**LODI UNIFIED SCHOOL DISTRICT**

**2020 Paving Project(s) – Phase II**

**ADDENDUM NO. 1**

March 06, 2020

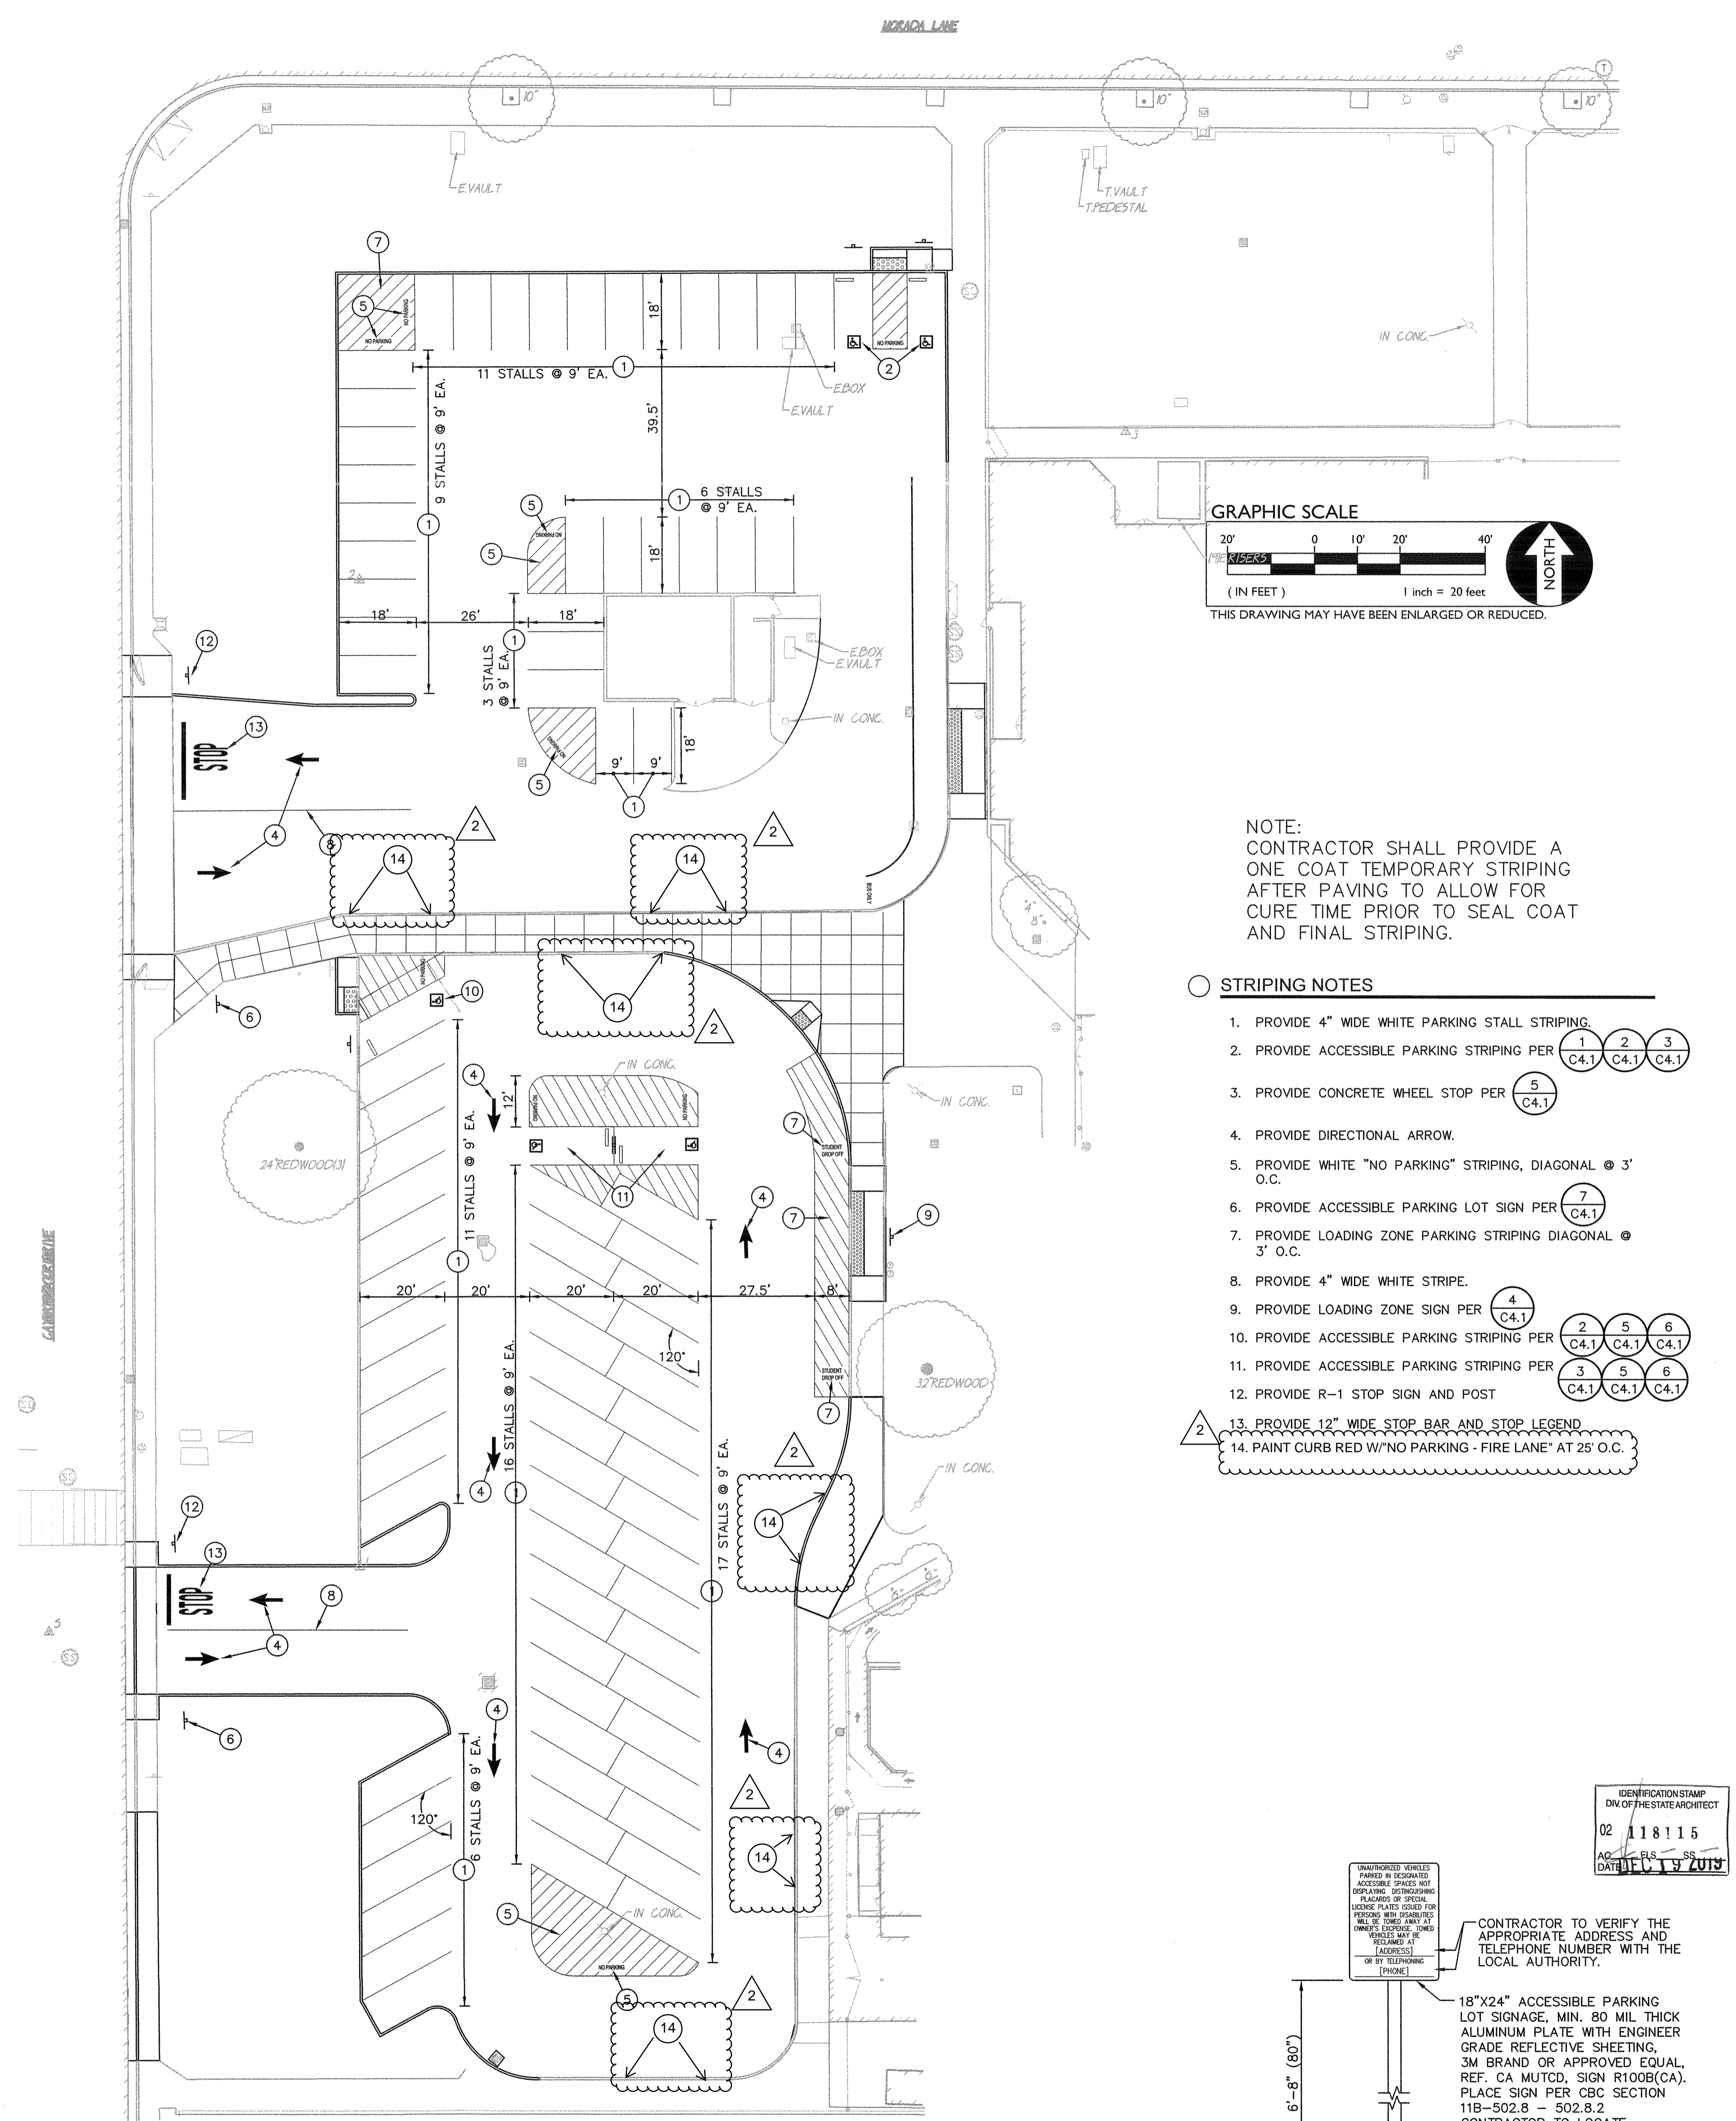
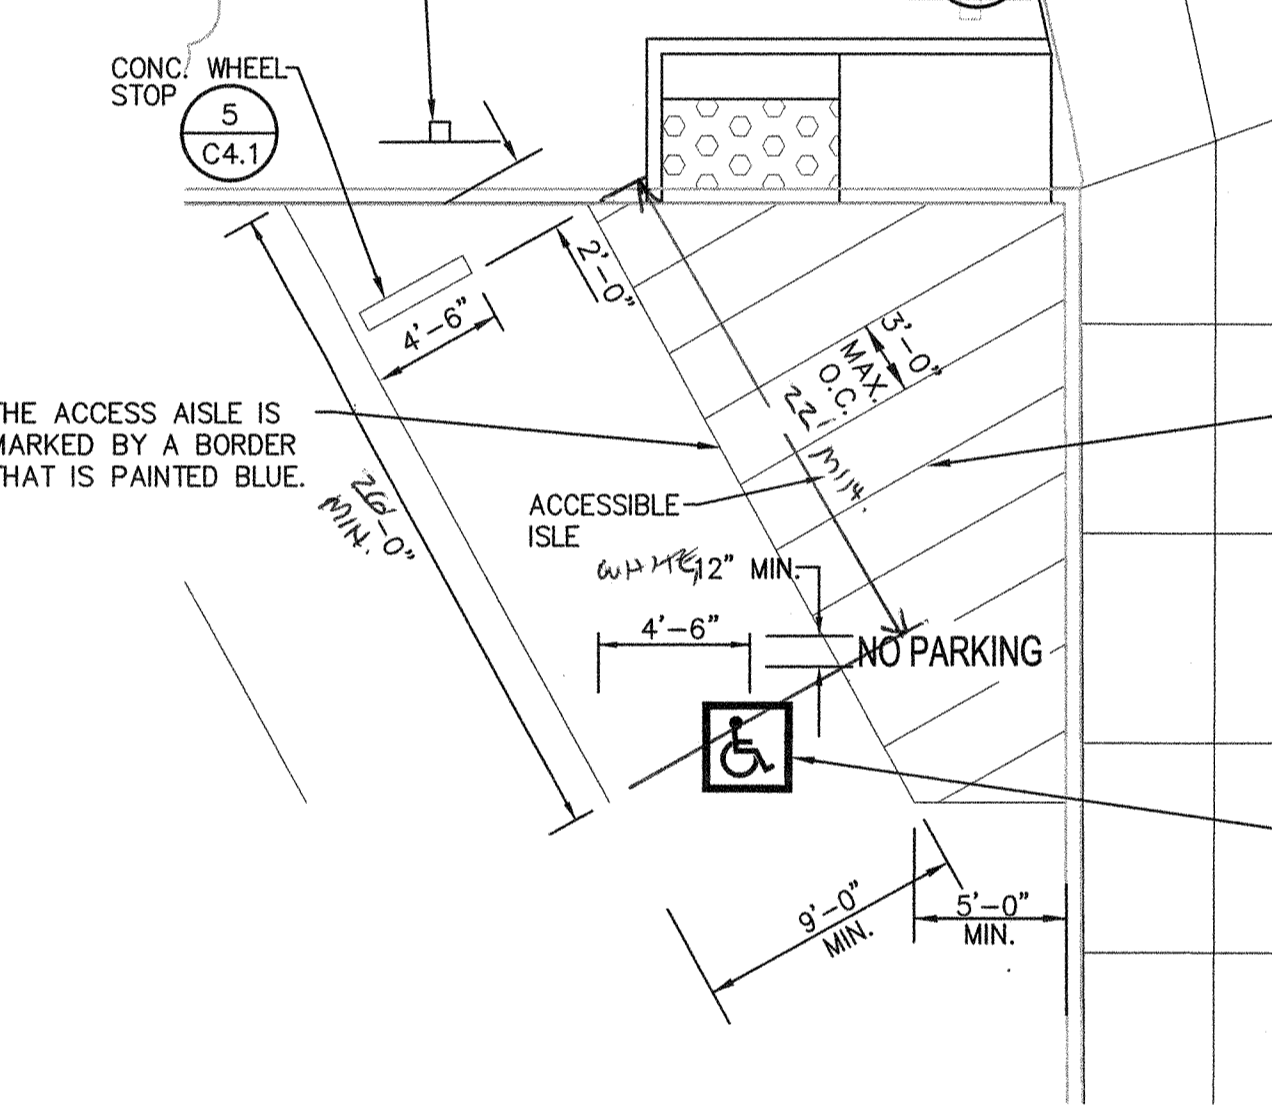
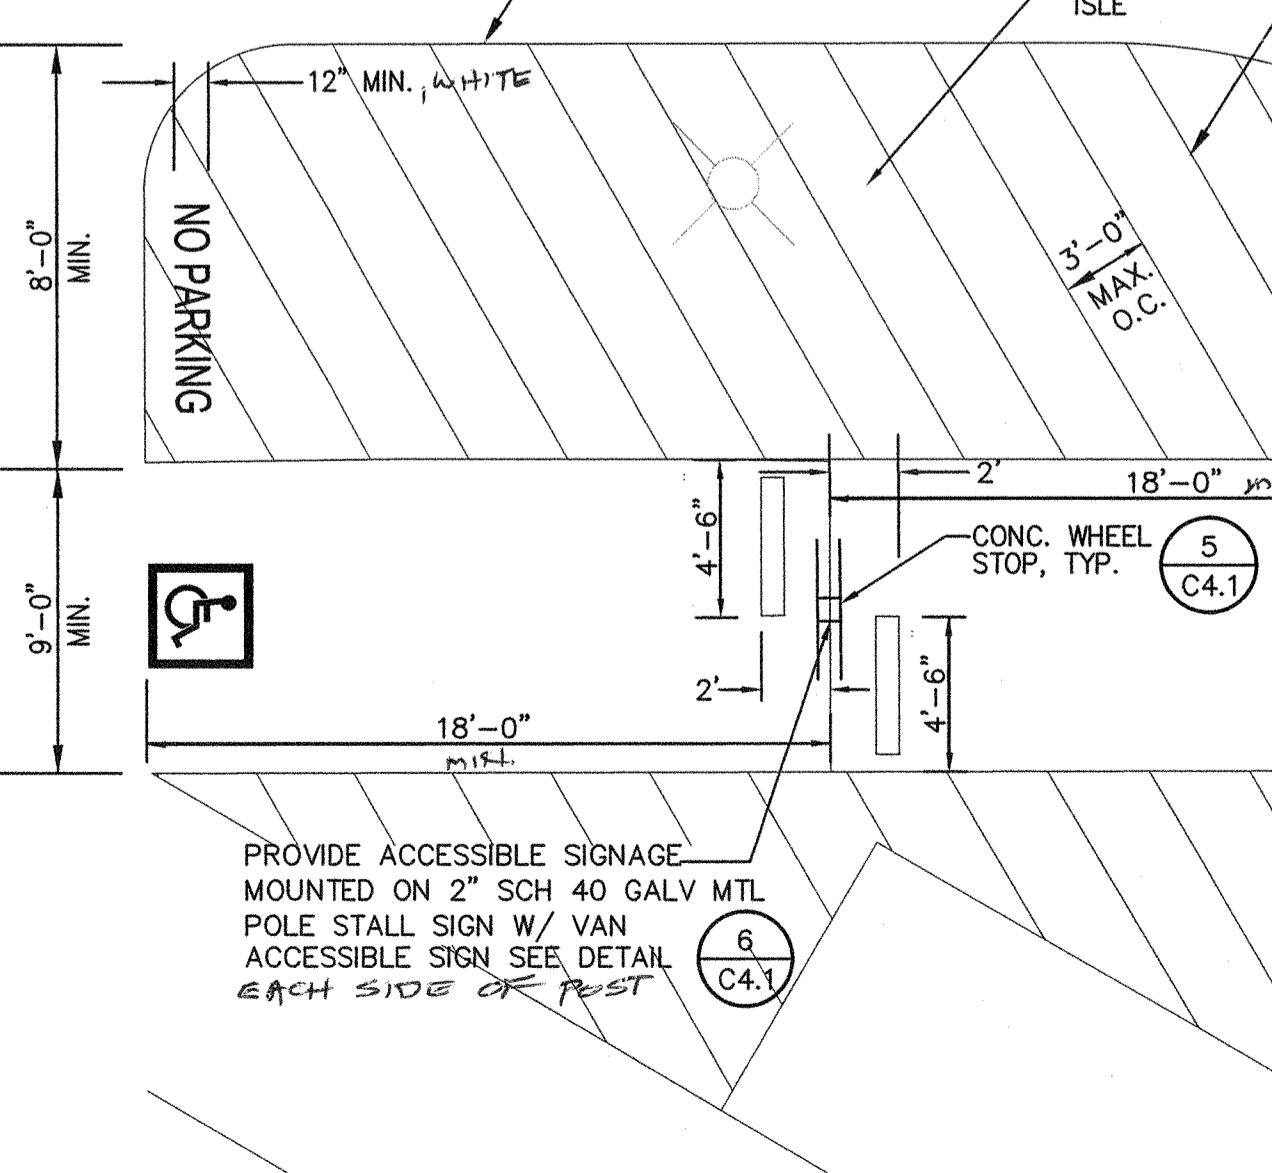
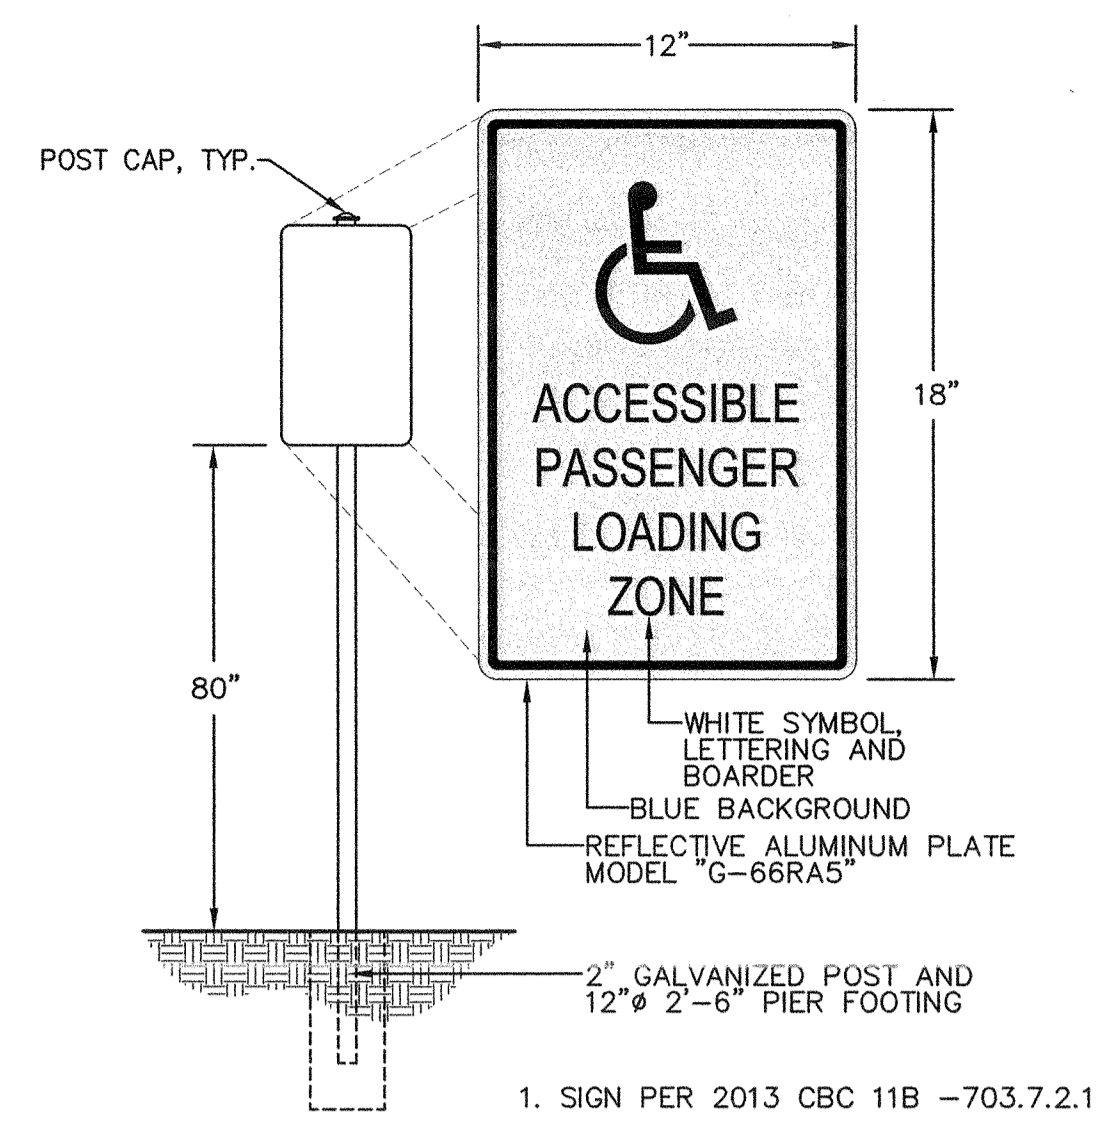
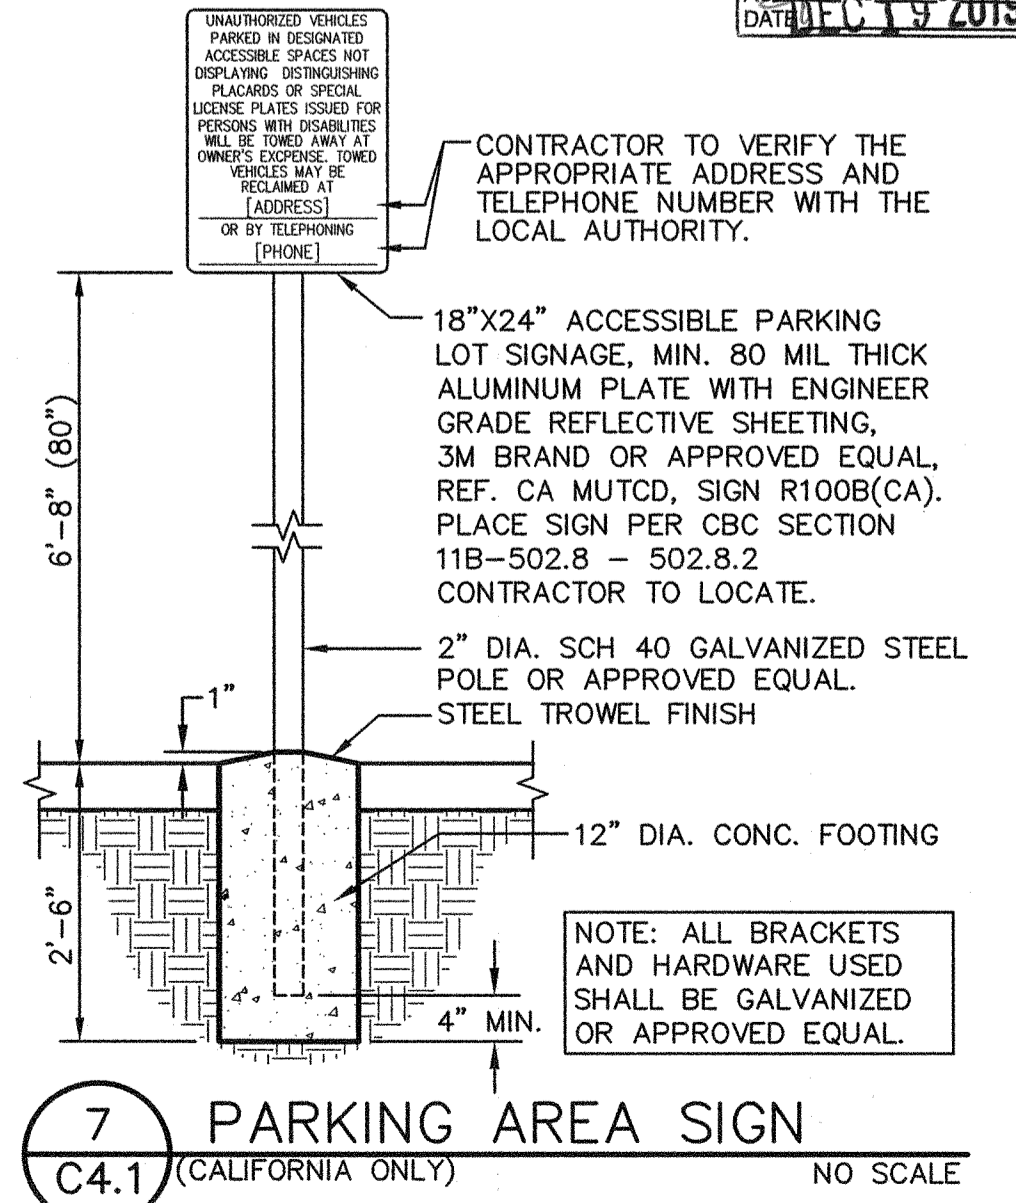
- 1.4 Westwood Elementary School - Project #0951-8251 – DSA #02-118115. Refer to Drawing Sheet C4.1 Striping and Signage Plan. **Replace** in its entirety with Drawing Sheet C4.1 Striping and Signage, dated 03/04/2020.
